SYMBOL LEGEND REVISION ITEM BALLOON FOCAL POINT FOCAL POINT DESIGNATOR INSPECTION BALLOON WATER TRACE IDENTIFICATION CENTER OF GRAVITY IDENTIFICATION	DETAIL LEVEL: N/A UNLESS OTHERWISE SPECIFIED MACHINE FINISHES SHALL BE: N/A	CLEANING PROCEDURE: MSW-DCP-101, LEVEL II UNLESS OTHERWISE SPECIFIED ALL OTHER SURFACE FINISHES SHALL BE: BRUSH	NO. ZONE ECN # REVISION DESCRIPTION DATE BY CHK
	P.O. Box 10 1925 Route 51 Clairton, PA 15025-3881 phone: 1-800-245-1656 web: www.lesker.com		15/16 Burgess Road Hastings, East Sussex, TN35 4NR United Kingdom phone: +44 01424 458100
	© Kurt J. Lesker Company "...vacuum science is our business"		NOTE: THIS DRAWING, AND ITS CONTENT, IS THE CONFIDENTIAL AND PROPRIETARY INFORMATION OF KURT J. LESKER COMPANY AND CAN NOT BE DISCLOSED OR USED EXCEPT WITH THE EXPRESS WRITTEN PERMISSION OF KURT J. LESKER COMPANY.
	SCALE: FOR REFERENCE ONLY 3/8 APPROVED BY: DATE: _____ CHECKED BY: DATE: _____ DRAWN BY: SHP DATE: 10/30/2012		TITLE: CHAMBER, BOX, 30"x20"x16" ID, 304 SS WITH DIFF PUMPED ORING

Q.C. BY USING 1:1 DRAWING: No DRAUGHTING: No DRAUGHTING BASED ON: -		MATERIAL SPECIFICATION: D 304L STAINLESS STEEL	DRAWING NO.: PRD093559-0100
KJLC PART NUMBER: BX3020C0013

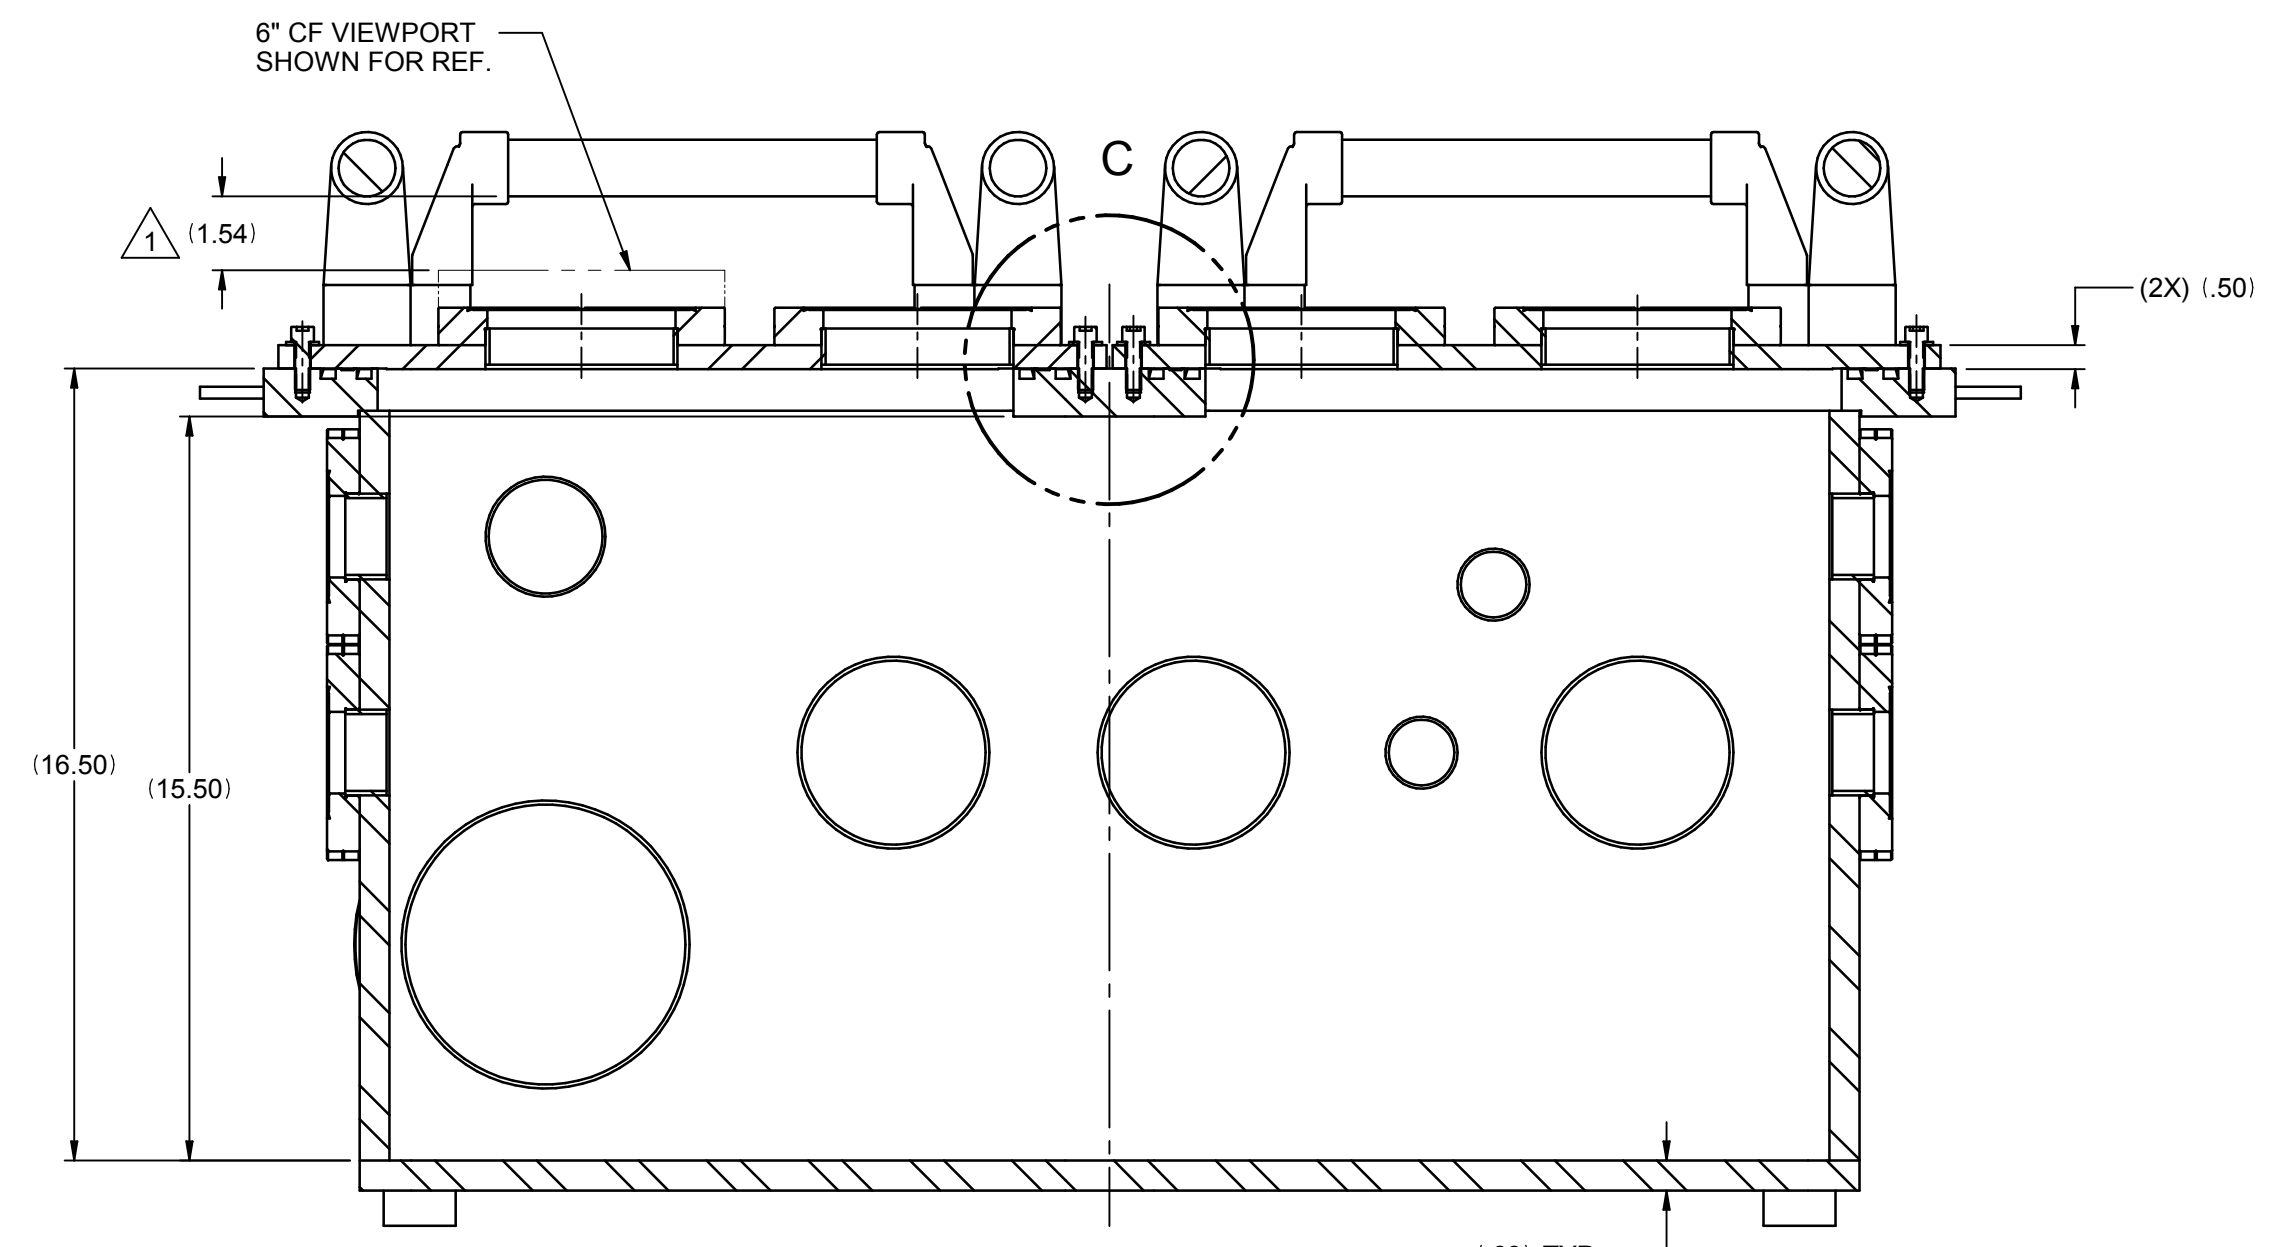
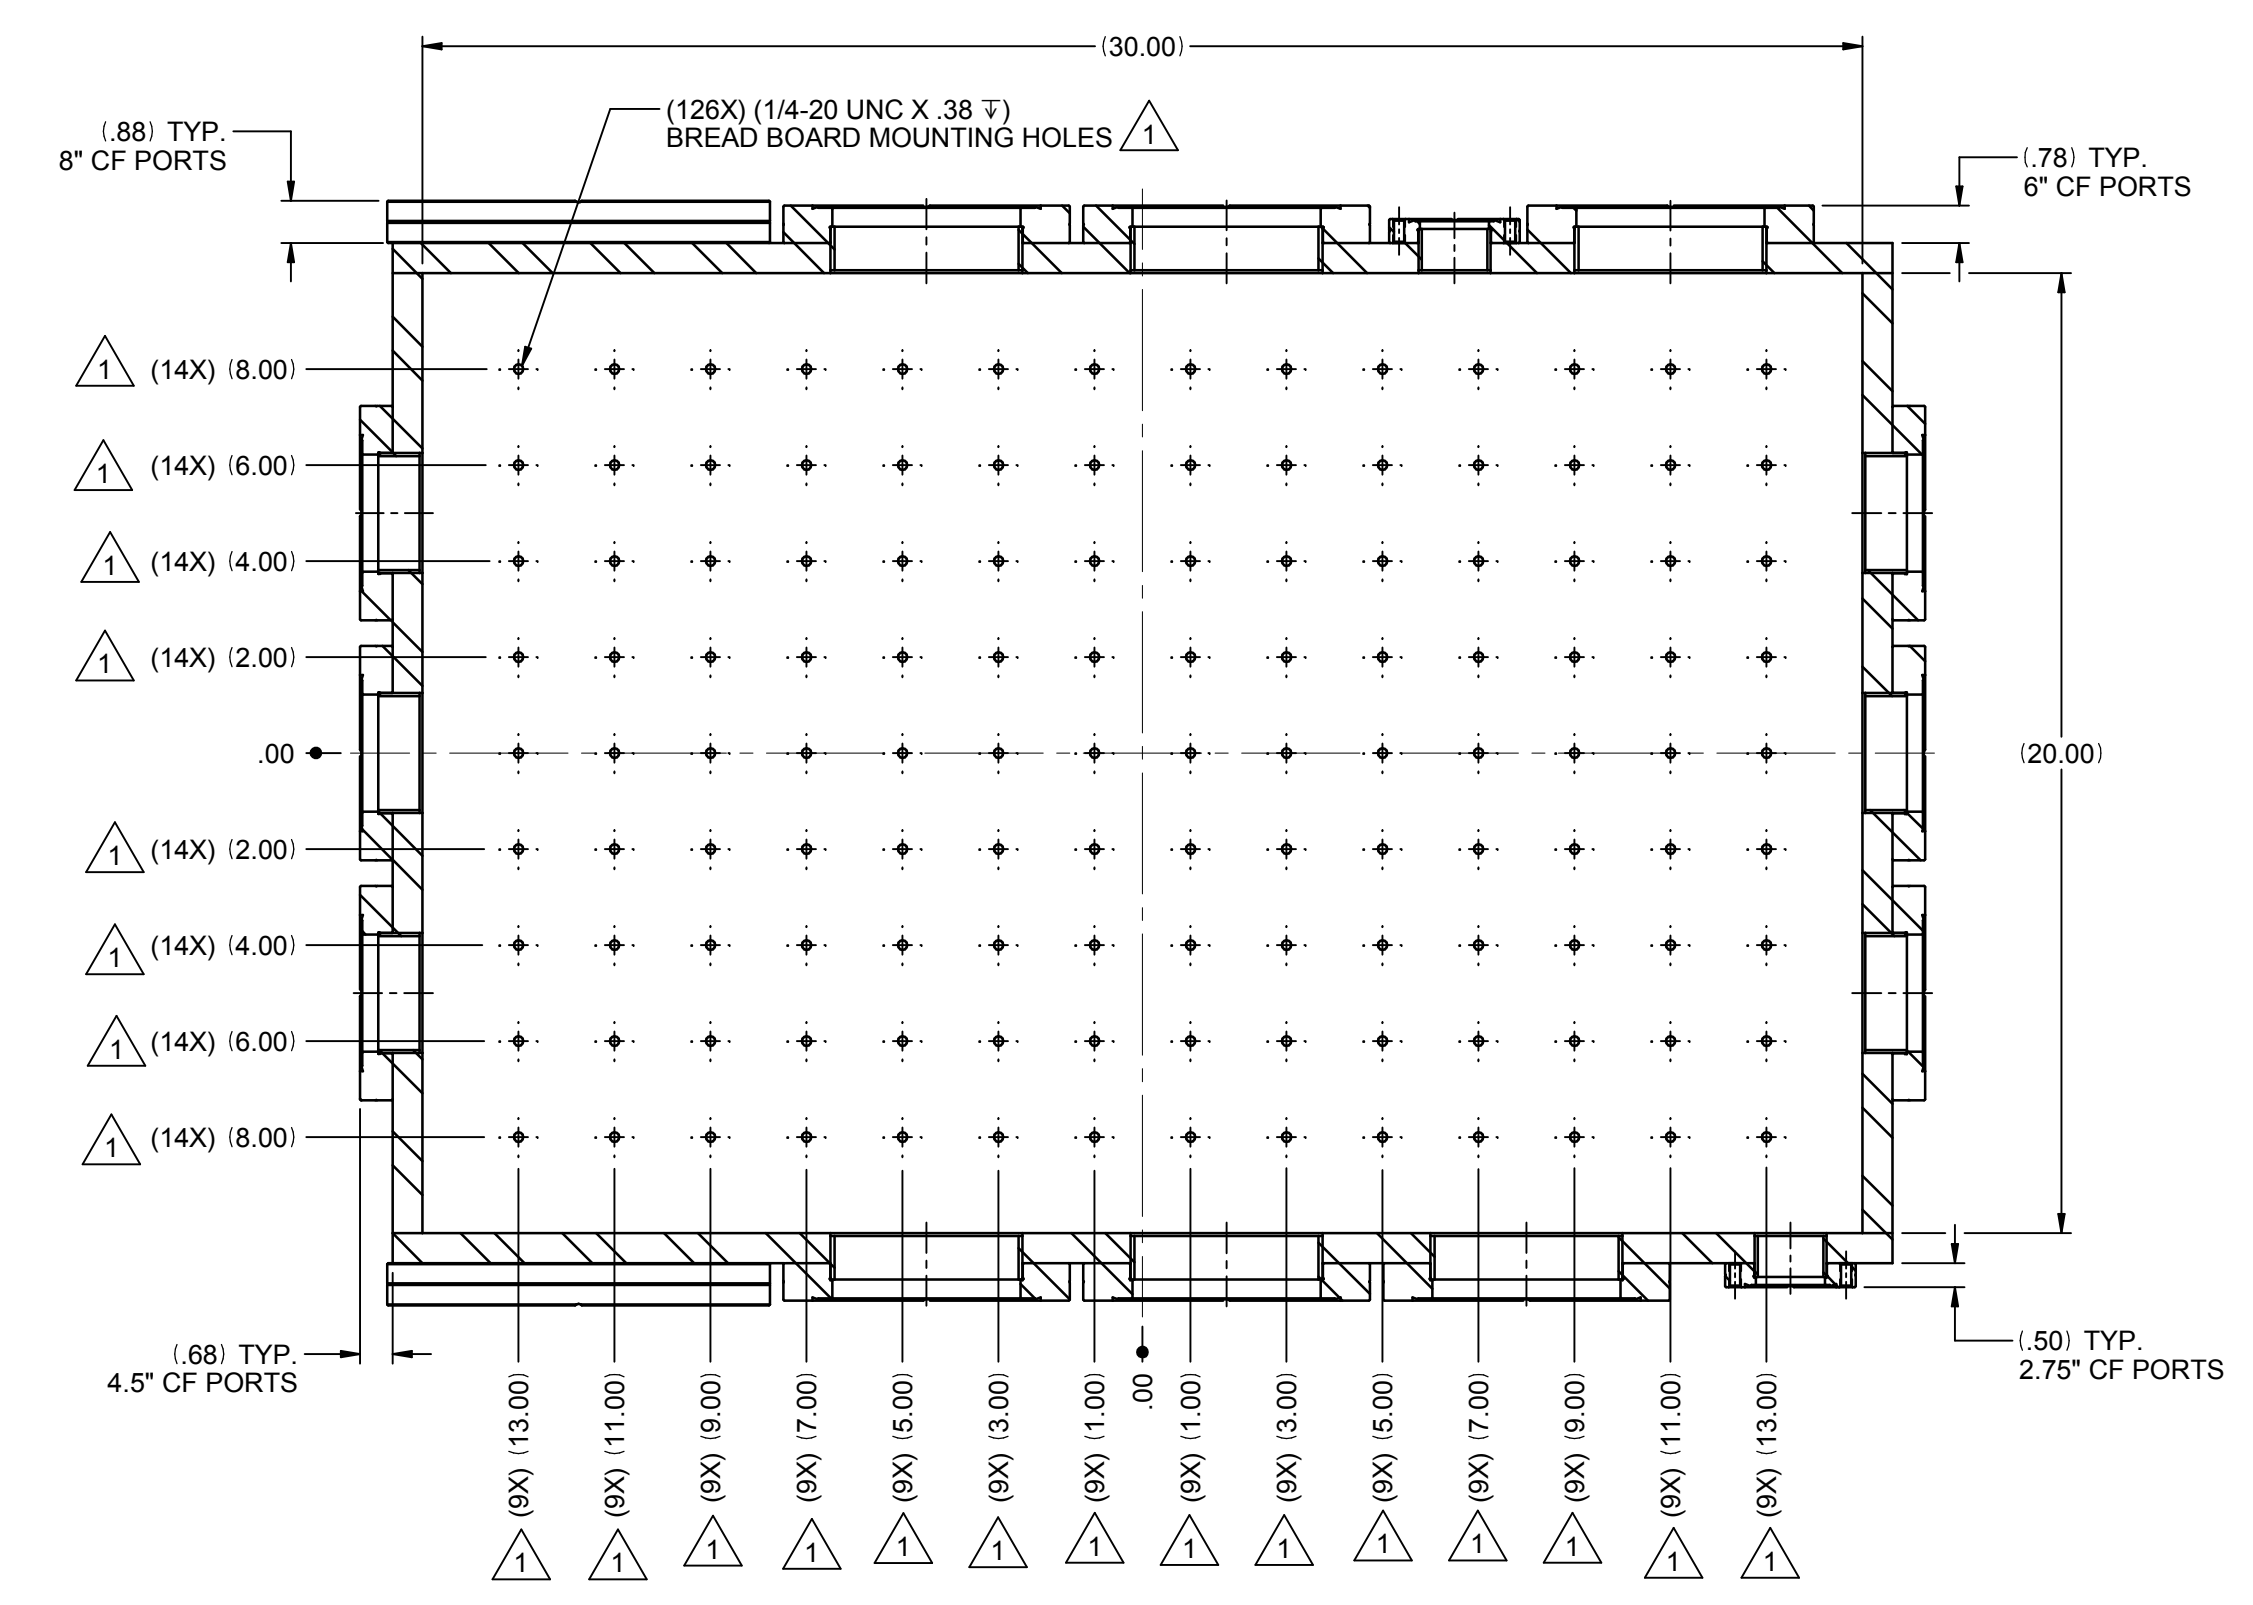
1	ALL	-----	ADDED PORT LABELS; MOVED "A", "B" & "C" PORTS UP 5"; SHORTENED MOUNTING BOSSES BY .5"; ADDED 2" X 2" HOLE PATTERN TO BOTTOM PLATE; LID MOUNTING HARDWARE WAS UNPLATED 1/4-20; ADDED LID HANDLES	11/12/2012	SHP	ENR
0	ALL	-----	RELEASED FOR CUSTOMER APPROVAL	10/31/2012	SHP	ENR
NO.	ZONE	ECN #	REVISION DESCRIPTION	DATE	BY	CHK
<p>P.O. Box 10 1925 Route 51 Clairton, PA 15025-3881 phone: 1-800-245-1656 web: www.lesker.com</p> <p>Kurt J. Lesker Company "...vacuum science is our business"</p> <p>15/16 Burgess Road Hastings, East Sussex, TN35 4NR United Kingdom phone: +44 01424 458100</p>						
NOTE: THIS DRAWING, AND ITS CONTENT, IS THE CONFIDENTIAL AND PROPRIETARY INFORMATION OF KURT J. LESKER COMPANY AND CAN NOT BE DISCLOSED OR USED EXCEPT WITH THE EXPRESS WRITTEN PERMISSION OF KURT J. LESKER COMPANY.						
SCALE: FOR REFERENCE ONLY 3/8			APPROVED BY:	CHECKED BY:	DRAWN BY:	SHP
			DATE:	DATE:	DATE:	10/30/2012
